Applicant: RadioLAN Marketing Group

Re: Modifications to FCC ID: MCI-397

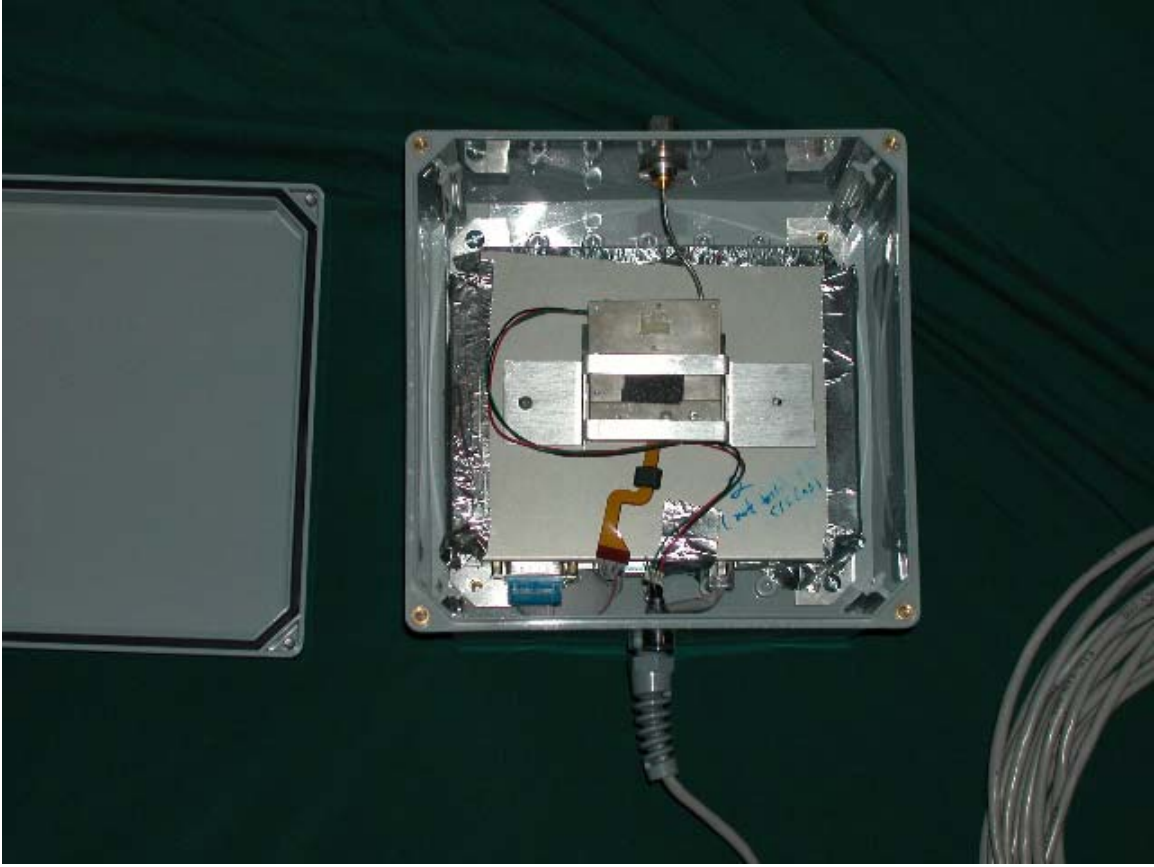
Metal tape will be placed around the seams of all production units, as shown in the photograph. This modification was required for passing radiated emissions testing.

RadioLAN has been informed of this requirement and will comply.
